Sigtronics SPA-600 Intercom to SCI-S6 Intercom Wiring Changes

Page 1. This is the first of 4 pages illustrating the wiring changes to take an existing SPA-600 installation and rewire it for a SCI-S6 intercom. The illustration below is of the original SPA-600 installation.

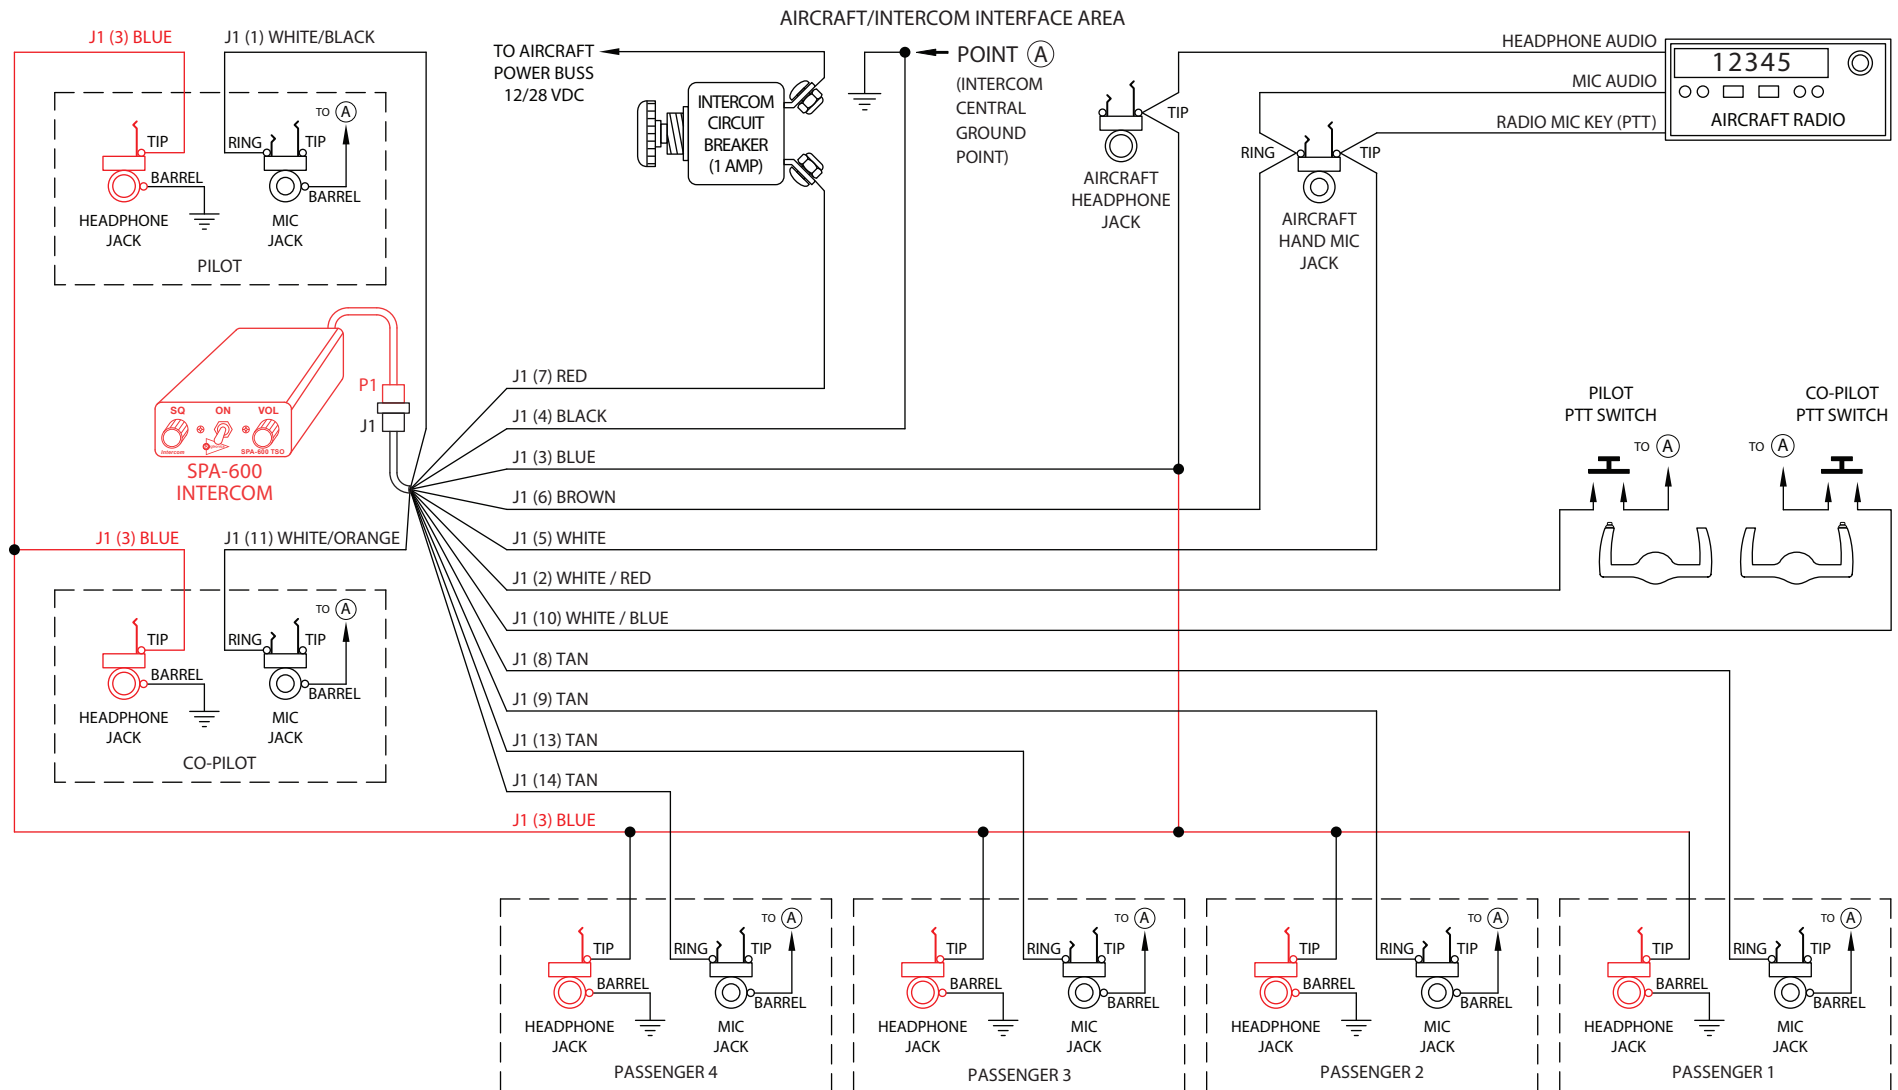
Page 2. Disconnect the tip terminal of the pilots headphone jack from the blue wire. Make sure that the **J1 (3) Blue** wire is still connected to the tip of the radio headphone line. Disconnect and remove the pilot, co-pilot and passenger headphone jacks.

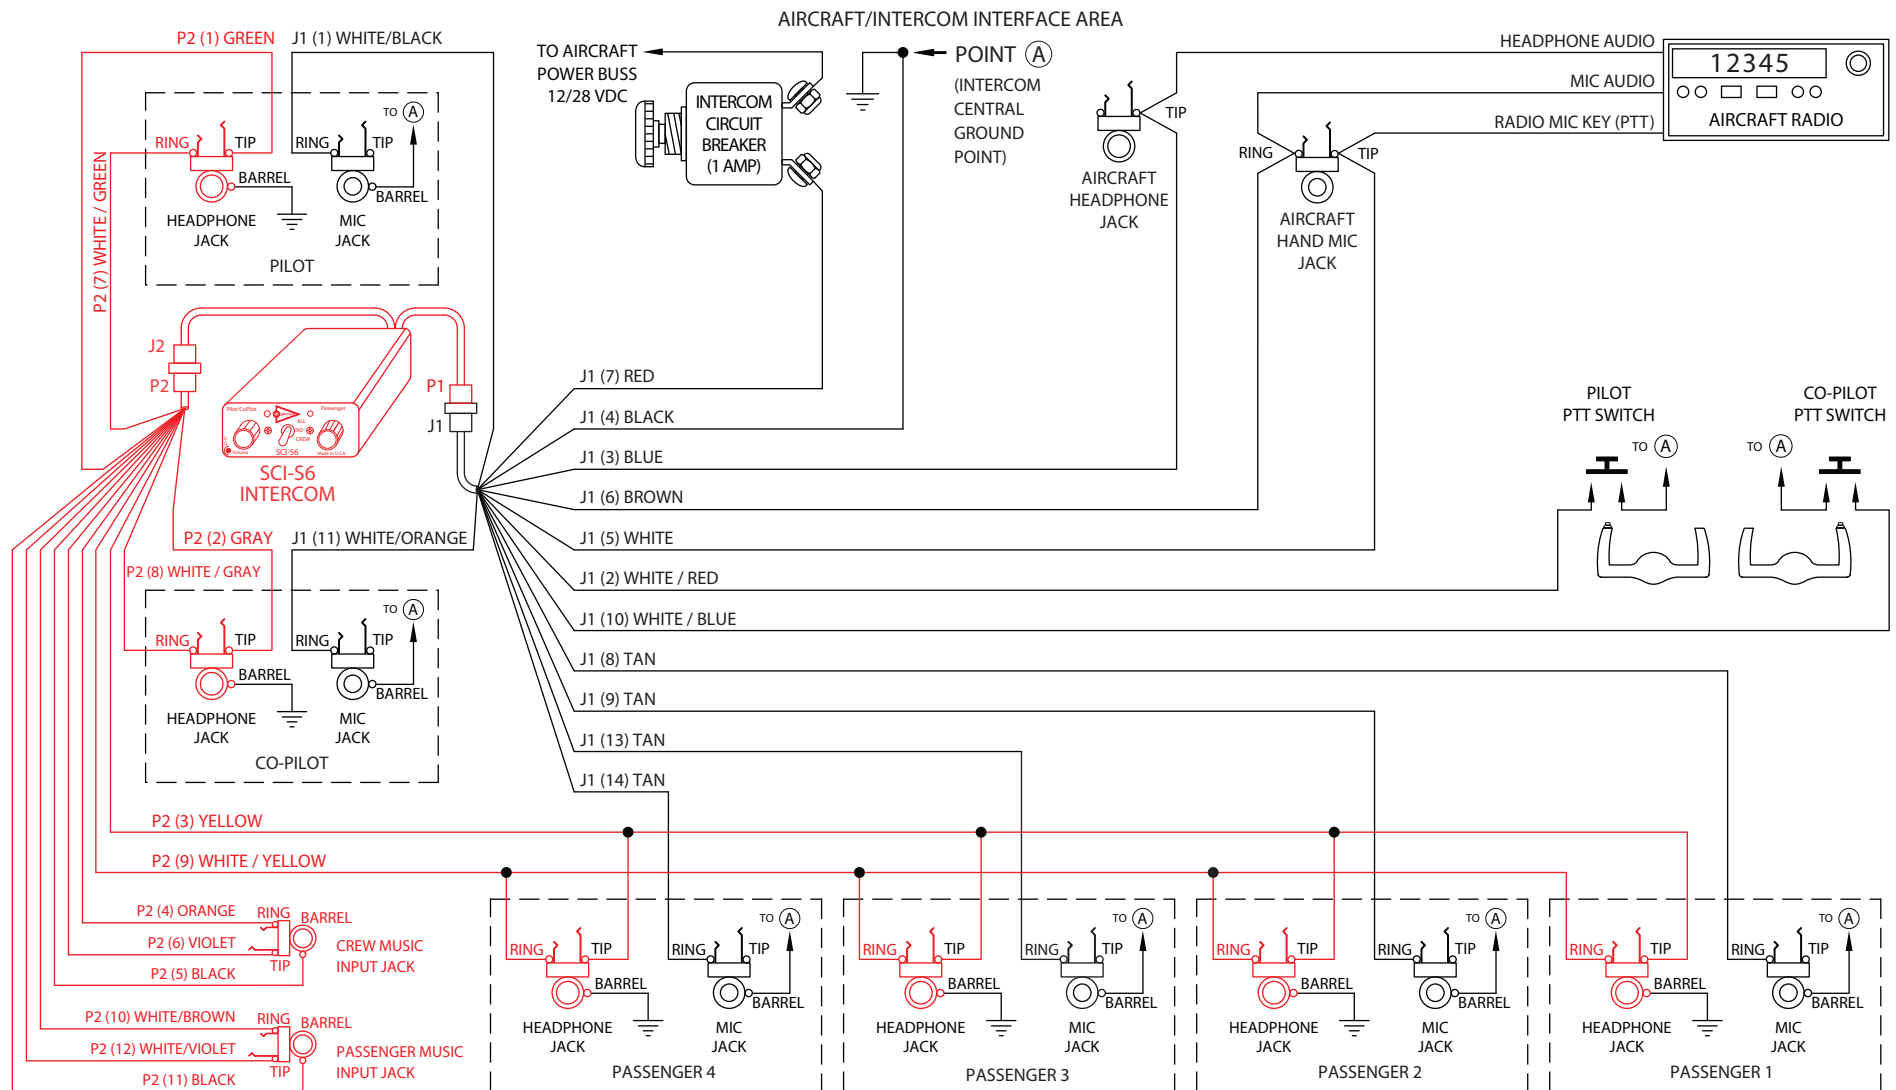
Page 3. Install the supplied stereo headphone jacks and connect to their respective pins on the headphone / intercom interface harness **P2**. Install the crew and passenger music input jacks and connect to the interface harness. The customer supplied music sources are connected at these jacks.

The SCI-S6 intercom is connected to the new interface harness **P2** and the existing harness **J1** of the original SPA-600 installation.
